ADDENDUM NO. 1

Water, Sewer, paving, Drainage, and Street Light Improvements to serve
South Oak Grove Estates, Section Six
CITY PROJECT NO.: 102739

Bid Date: January 14, 2021
Addendum No. 1: Issued January 8, 2021

PAVEMENT DETAILS

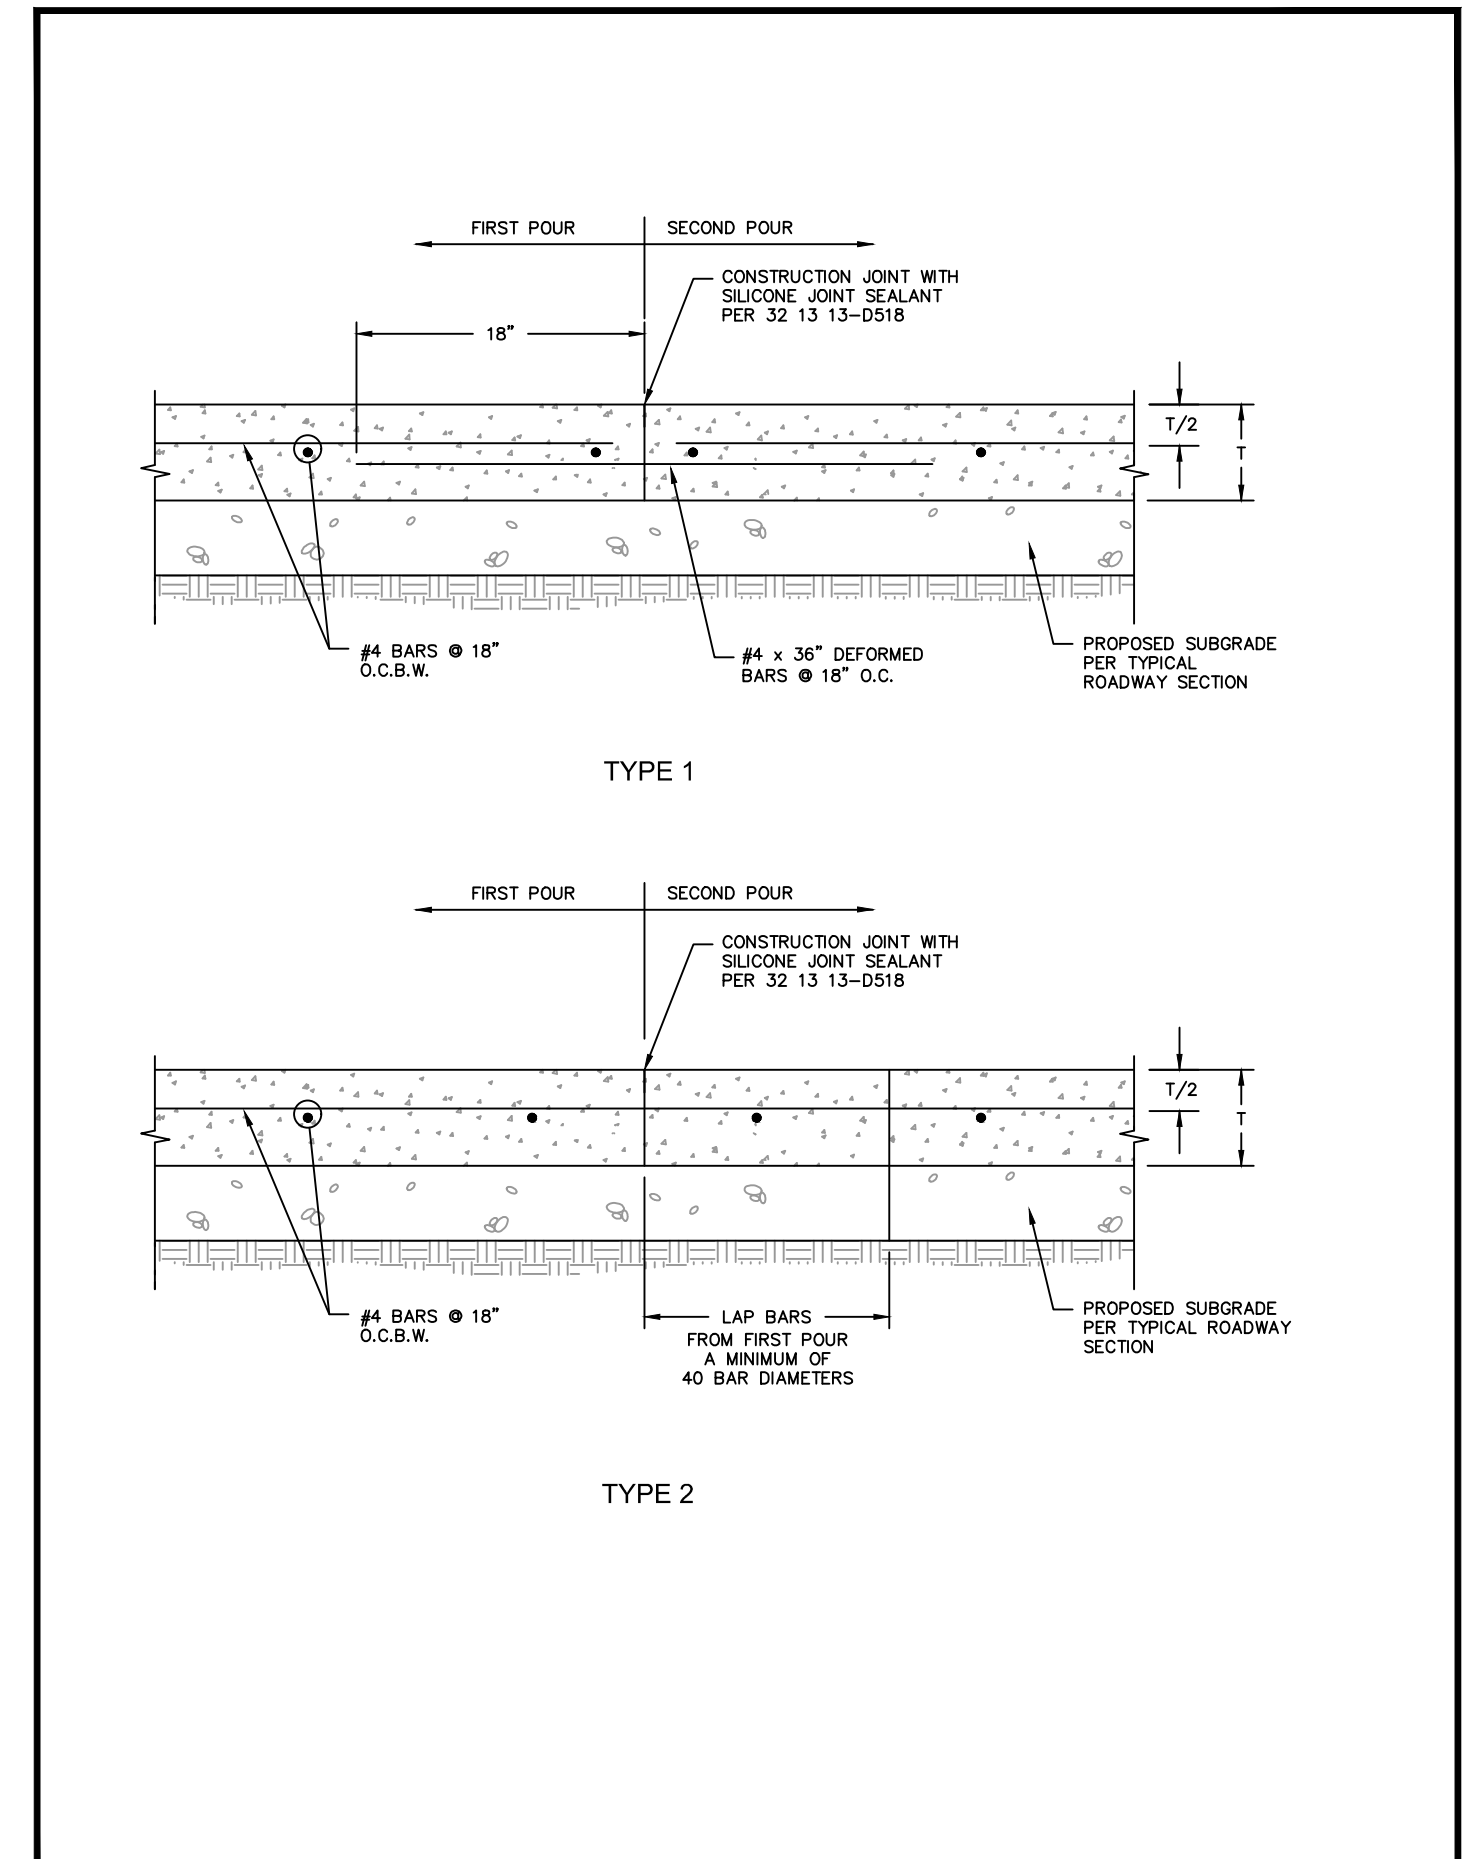
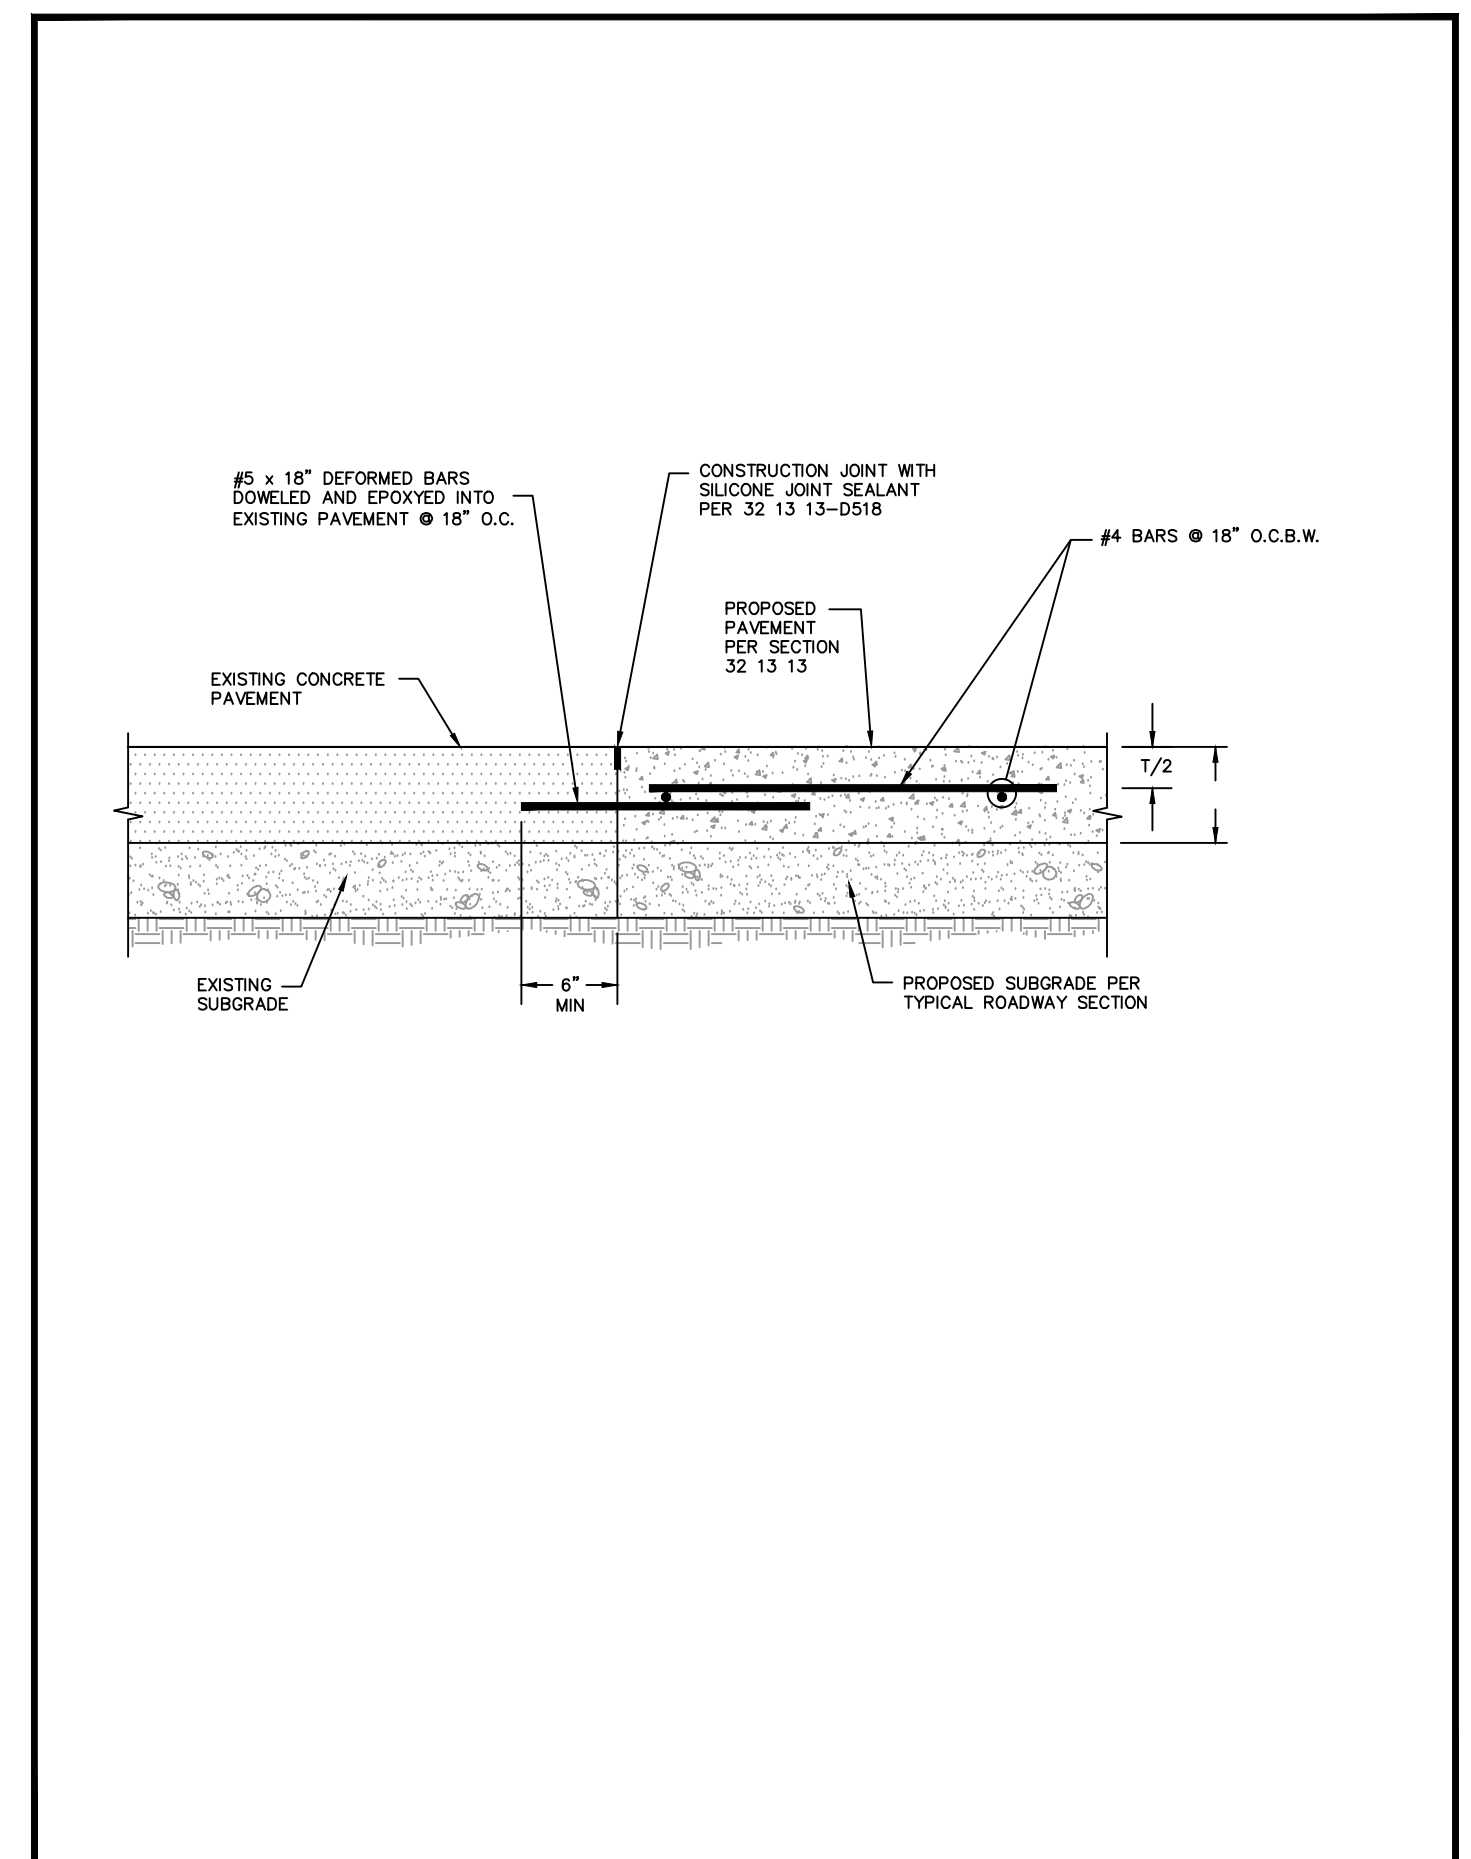
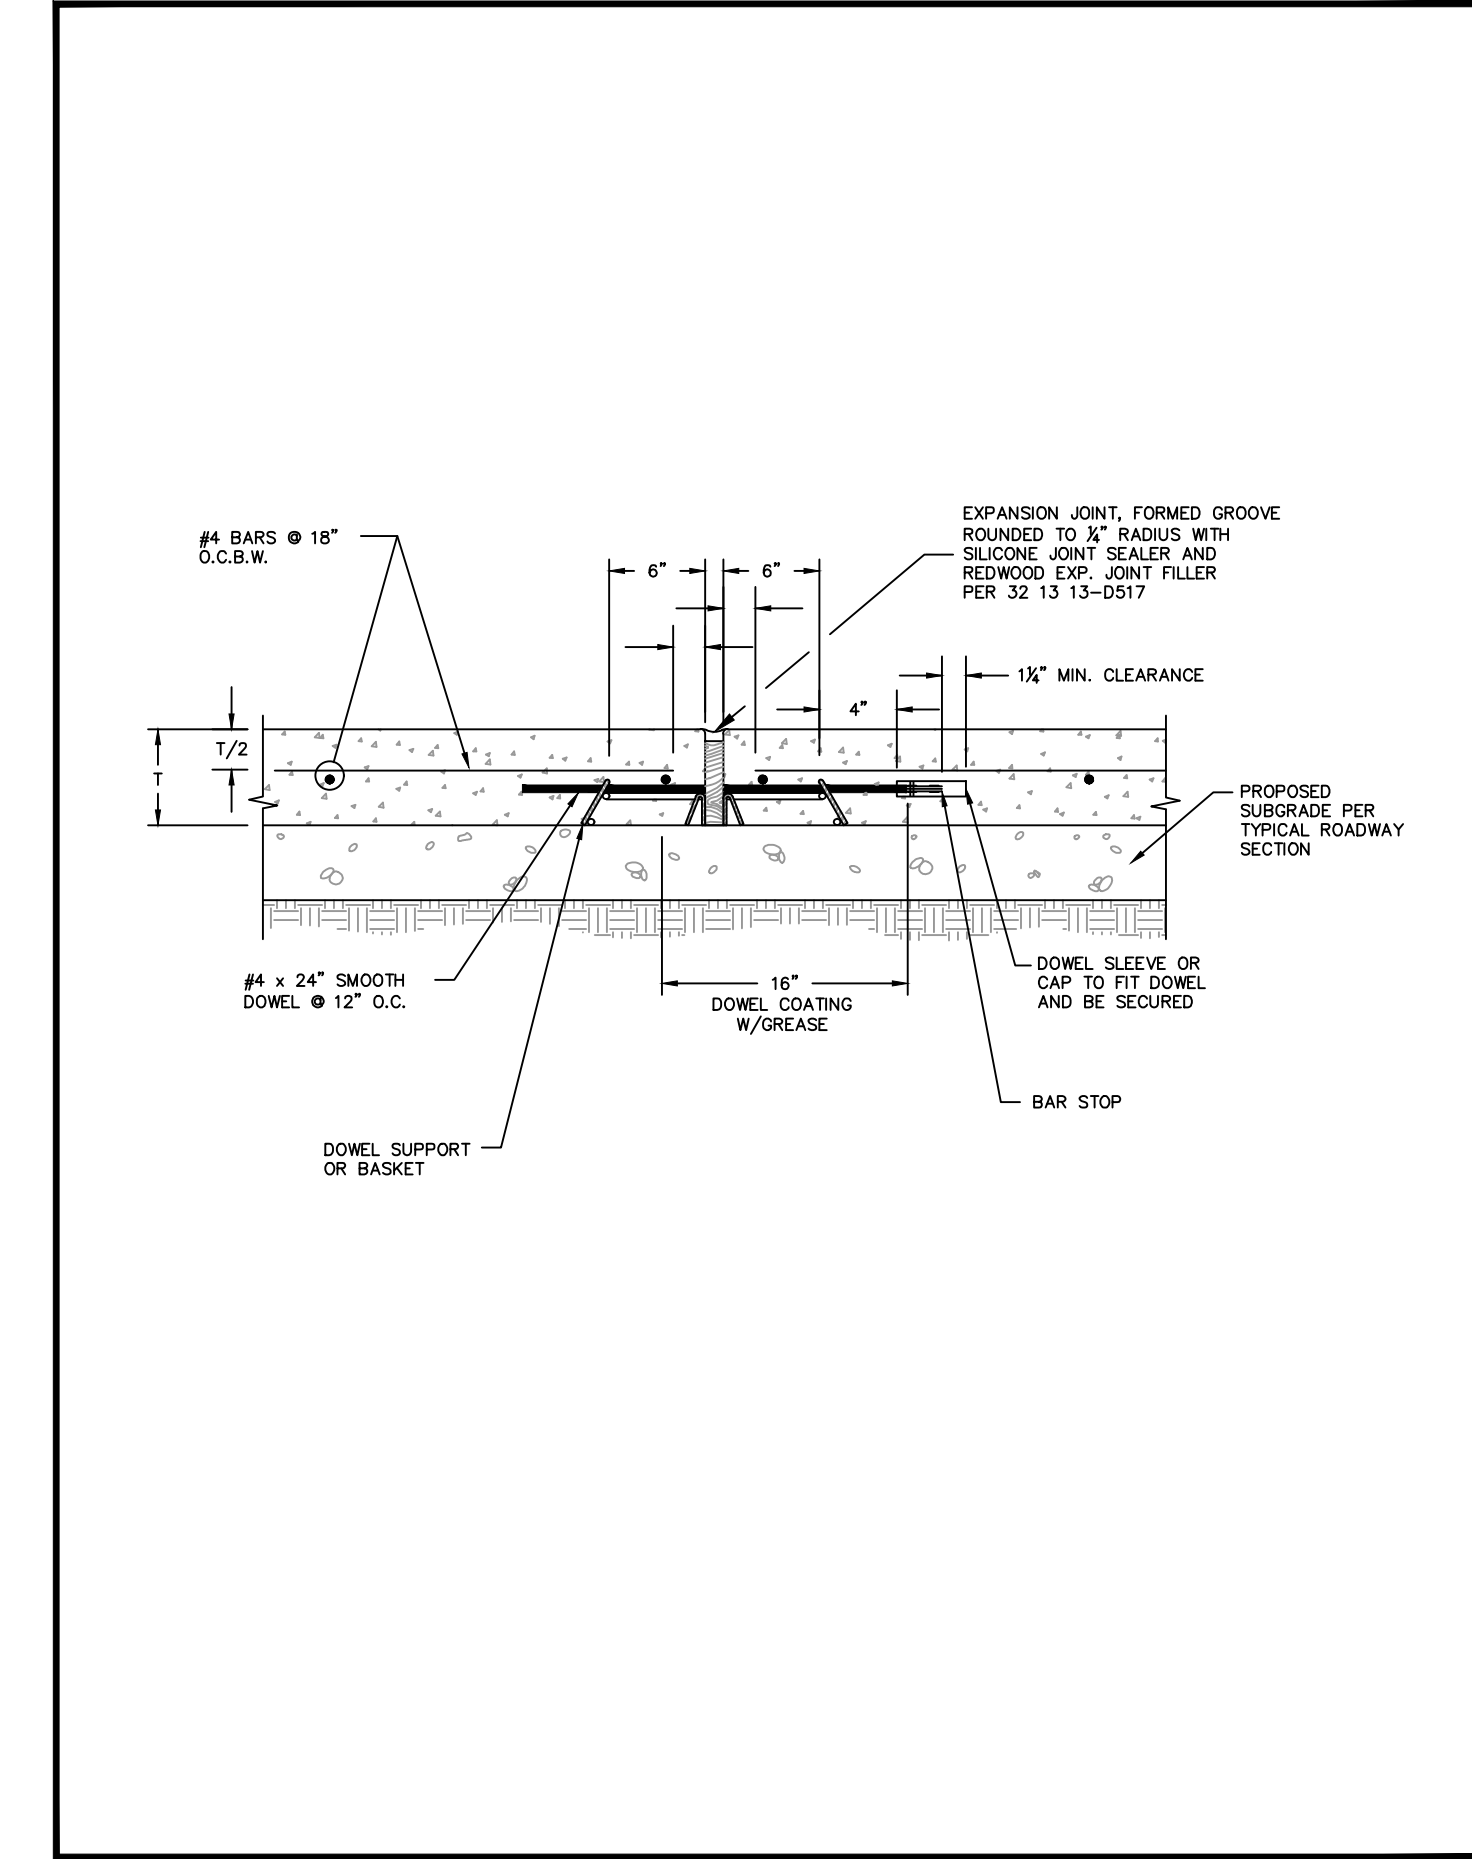
Sheet 21	Modified the lime stabilization construction note.
Sheet 27	Modified contraction joint spacing.
